CONWAY

CONWAY HISTORIC DISTRICT COMMISSION MEETING

**OLD CONWAY DESIGN OVERLAY DISTRICT
CERTIFICATE OF APPROPRIATENESS REVIEW
OLD CONWAY VILLAGE, LP**

DISCUSSION AND PRE-REVIEW
New December Comments in Red

Site Plan showing project locations

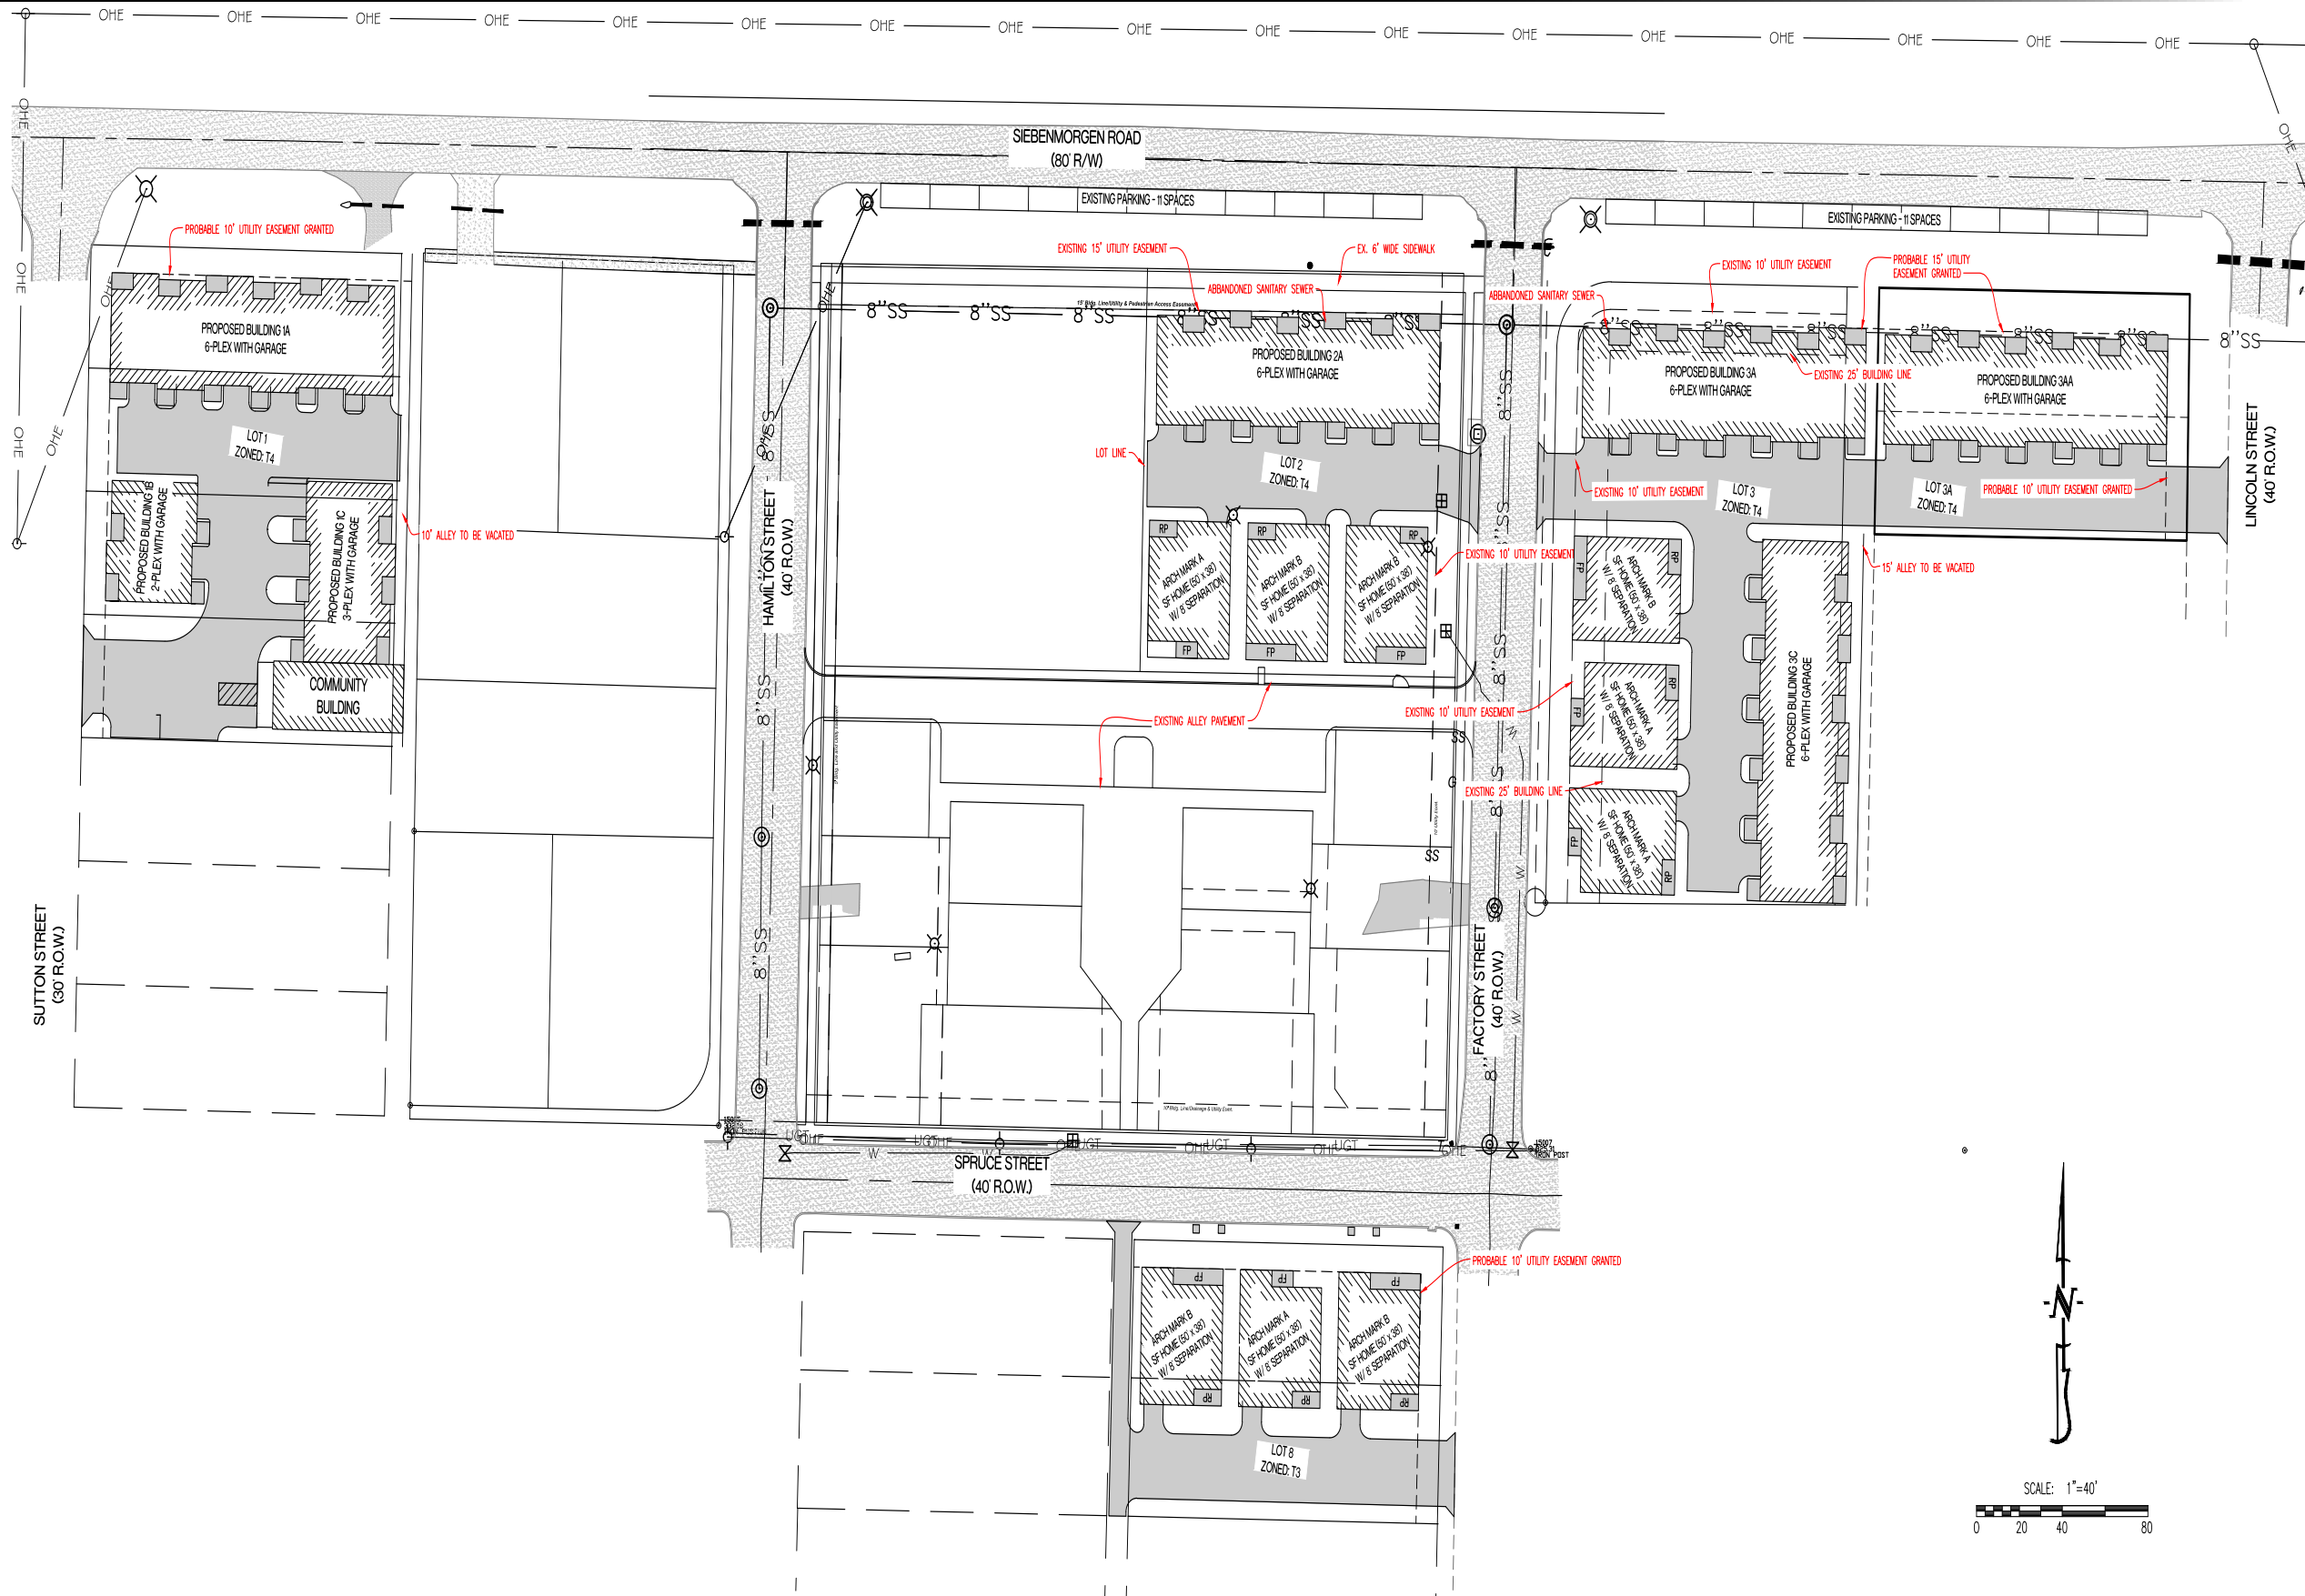
Orientation. The direction in which the front of a building faces. Most townhomes are oriented to face abutting streets. However, 3 units are facing internally with the “front” facade facing abutting property (Lots 1, 2, and Lot 3. The rear of some units on Lots 1 and 3 will be facing the abutting property. **The front facades of all proposed single family homes face outward to the public streets or public alley.**

Alley. There are 3 unbuilt alleys and one newly constructed alley in the project area. An alley in Lot 1 and part of an alley in Lot 3 will need to be closed in order to construct as proposed. **The City Council approved closure of these alleys at the November 28 City Council meeting. The newly constructed alley is used as the “front” of the single family residences in Lot 2.**

Driveway/Parking/Carport. Driveways and parking areas are planned for each townhome unit. The parking areas will be internally located between townhome units and will serve as the garage entry points. The townhome buildings will screen the parking areas and present a more pedestrian friendly facade to the public streets and alley. All proposed single family structures will have driveways accessed from an alley or parking area with rear garage entry. The driveway serving the 3 single family structures south of Sutton could possibly be reduced. The existing 10 foot alley on the west side of these structures could also be used to provide access.

Single-Family Home (Opt B) - rear and side perspective

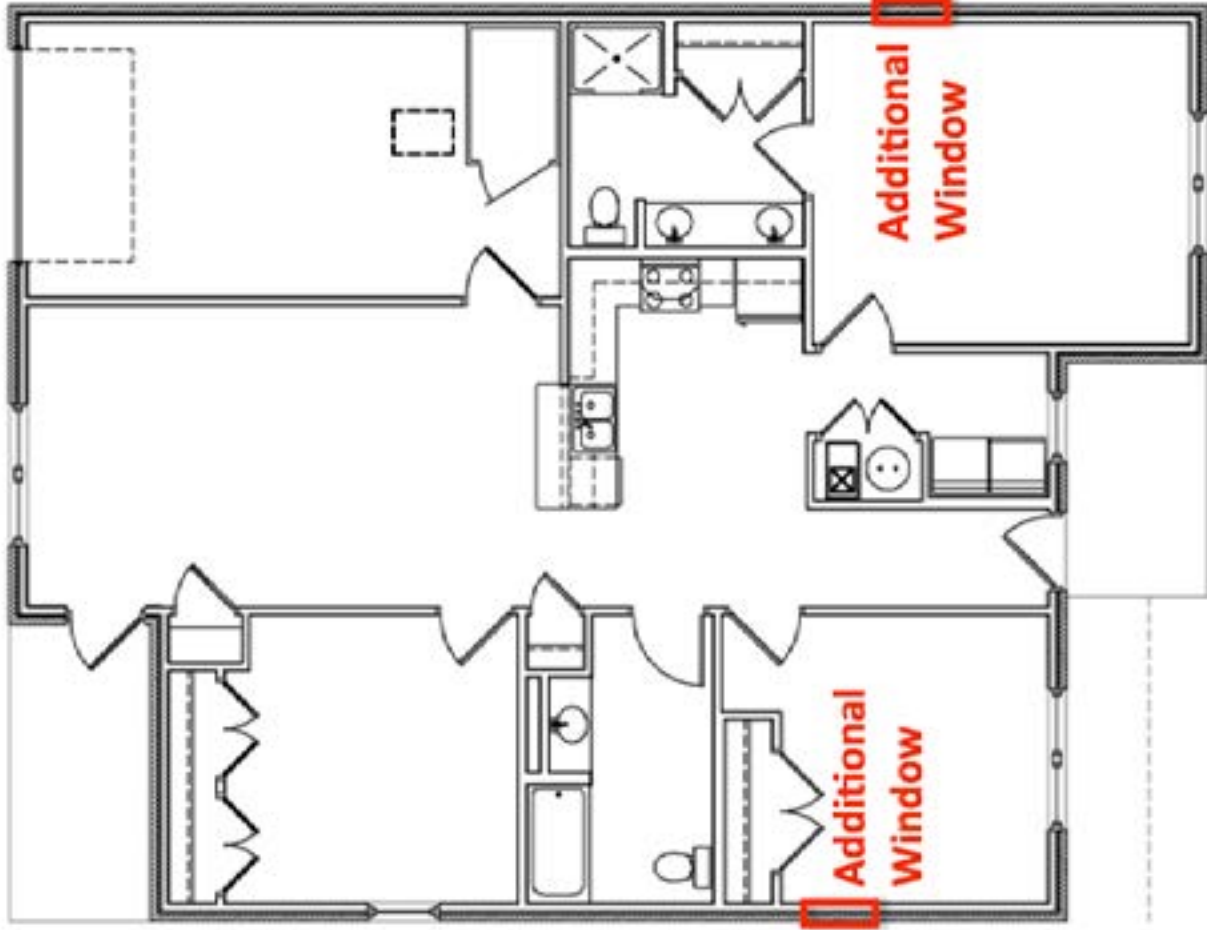
Single Family Residences. **There are now 2 single family residence designs The 9 residences will use the same floor plan but will have two exterior designs that are mixed and mirror imaged to provide variation. On Lot 2, a Option A will be set on the west and two mirror imaged Option B’s will be set in the center and east side. On Lot 3, two mirror imaged Option A’s will be used in the center and the south. An Option B will be used on the north. On Lot 8, two Option B’s will be used separated by an Option A in the center.**

Façade, wall area, rhythm. Facades shall be compatible with surrounding historic structures in proportion of wall to opening area. The townhomes appear to have an appropriate number of windows and doors. **The long sides of the Siebenmorgen townhomes are facing north creating a street friendly facade. The single family residences seem to have the appropriate level of windows and doors with the exception of the two front bedrooms. The submitted elevations show a window on the left side of the residences but it is not shown on the floor plan. This window along with another one on the right side of the residence will better meet the Old Conway Overlay transparency regulation of 25-40%.**

Entries, Porches, and Porticos. Appropriate entry points are provided. Old Conway Design Regulations specify a 6 foot minimum porch depth. The applicant has modified the townhome front porches to a minimum of 6 feet x 10 feet. The townhome’s rear porch/portico is how as 6 feet x 8 feet. **The single family residence Option A has a front porch depth of 6 feet and 10 feet wide and a rear porch depth of 6 feet x 13 feet wide. Option B has a front porch depth of 6 feet x 23 feet wide and a rear porch depth of 6 feet x 13 feet wide.**

Decks/Plaza Space. **Option A appears to show a small concrete patio space in lieu of a rear porch.**

1. The development shall be constructed as submitted. Variations may be allowed for technical reasons and are approvable by the Director of Planning.
2. Additional windows shall be added per staff sketch in the single family residence front bedrooms.
3. First floor heights 9 foot minimum.
4. All structures shall be clad with cement board siding.
5. Fascia and soffit materials may be vinyl.
6. Tree preservation, remediation, and general landscaping shall be determined and approved as part of Planning Staff landscaping development review.
7. Setbacks, easements, etc as approved by the Historic District Commission in November will be recorded as part of the platting process.
